Seattle Community Design Process - What We Heard

Feedback from May 2012 Public Session on Portage Bay Bridge and West Approach Bridge

Box girder concept

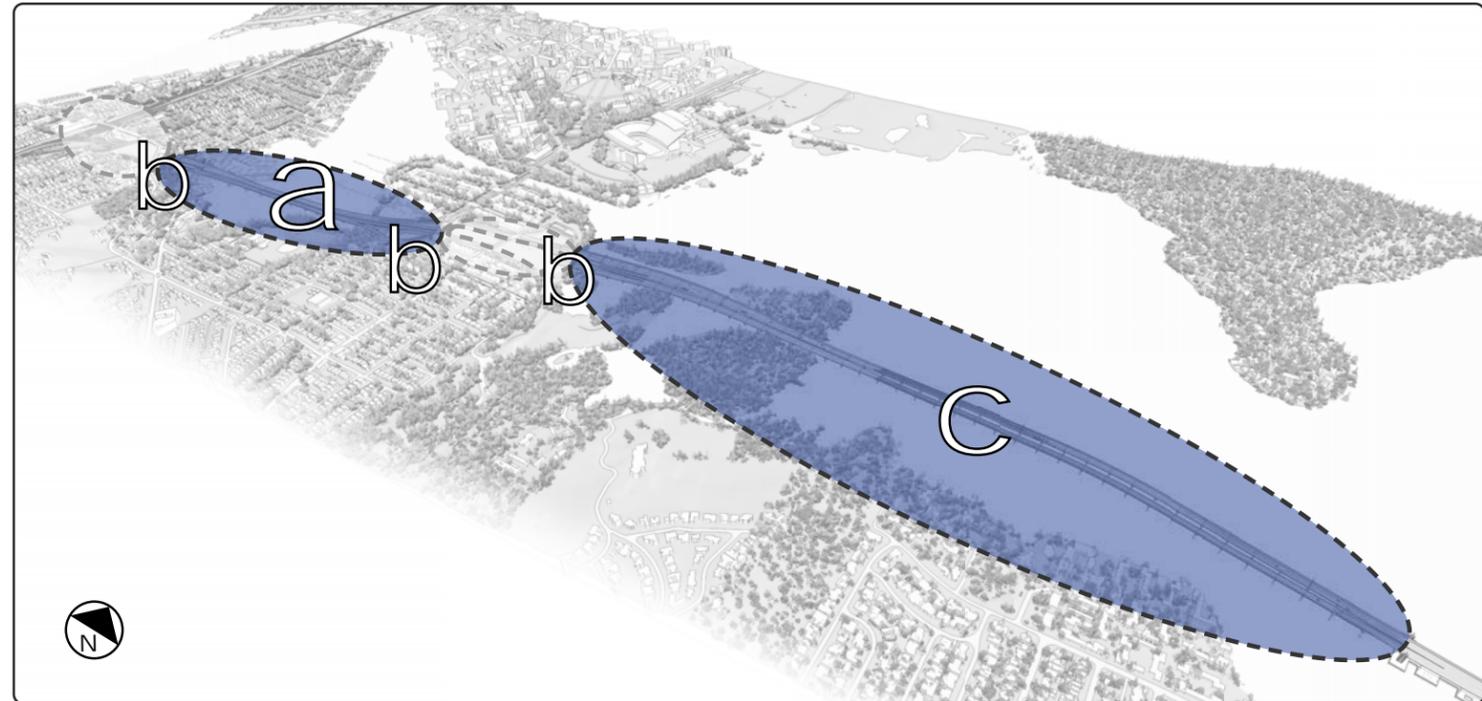
- o There was support for a box girder bridge. People believe this option is desirable for various reasons, including:
 - It places most of the structure below the bridge deck, allowing for better views above the deck
 - The design seems "clean", "simple", and "cost-saving"
- o Reasons that people do not prefer the box girder option include:
 - It appears "massive", "boring", and "cheap"
